Conceptual Site Model

2018.05.16 Notes

Cedarburg Light & Water

Site Information: Cedarburg Light And Water Power Plant

FID#: 246100800 SIDEWALK MEQUON AVENUE -APPROXIMATE LOCATION OF FIRE HYDRANT (SITE DATUM) CONCRETE 0 UNDERGROUND BRICK-WALL BUNKER FORMER POWER PLANT 3/29/18 Closure Committee Reprendations

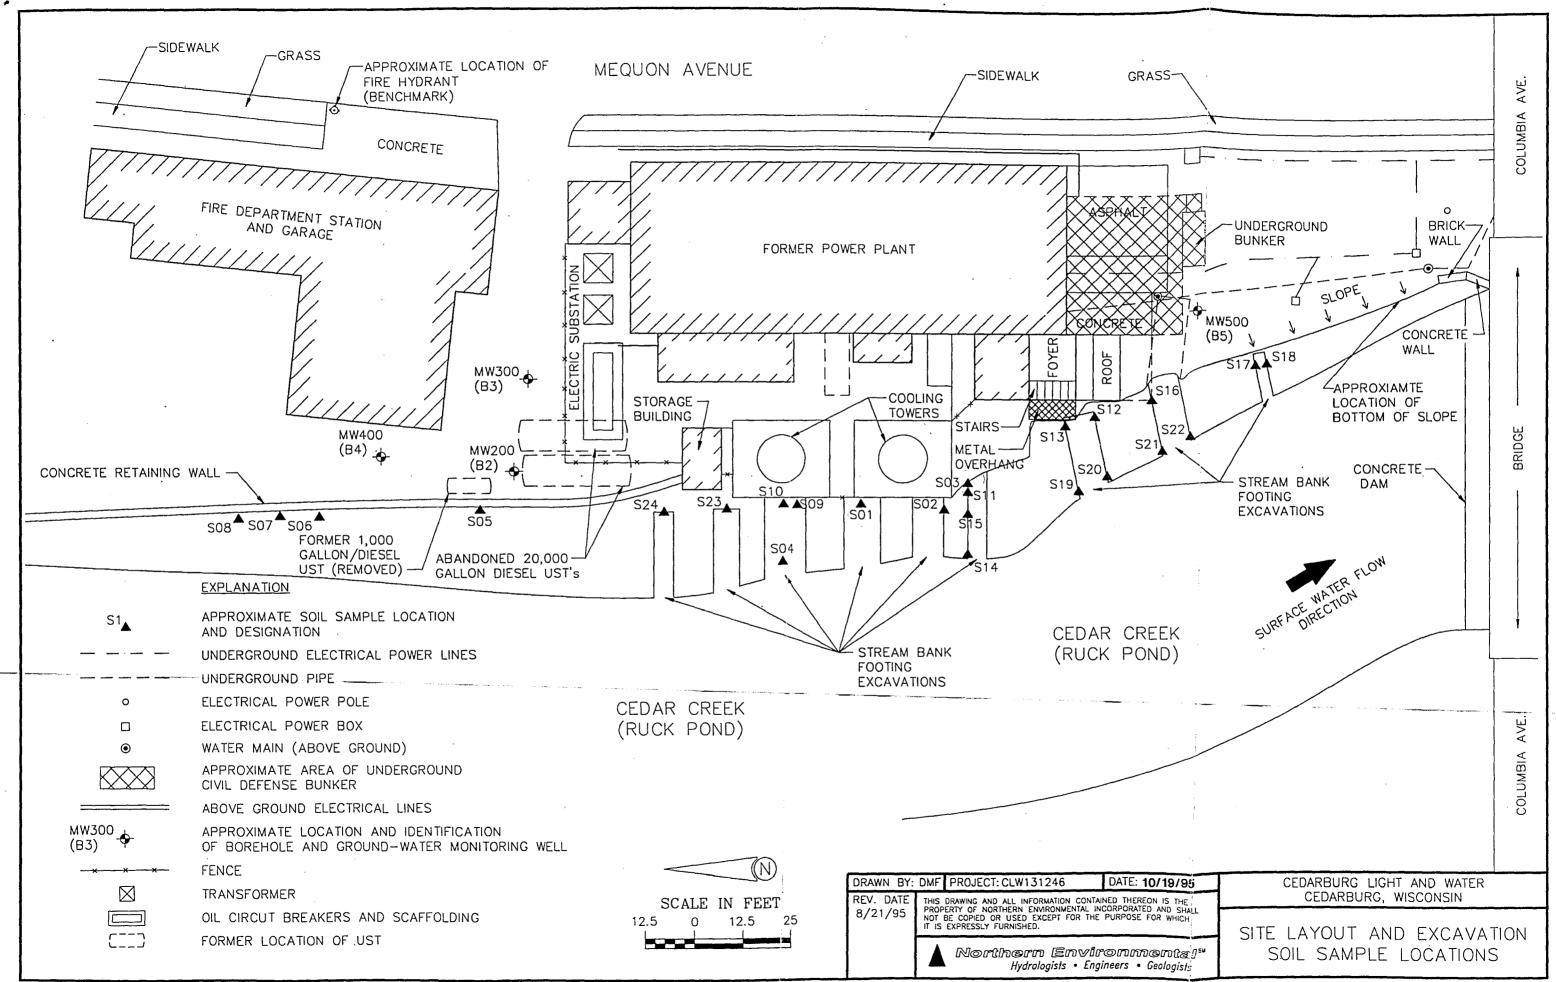
Theed add time Soil Sampling ound

Herd correct Helleval + god Sampling round

(Table top) VI analysis

SHOW SINP Within 60 days
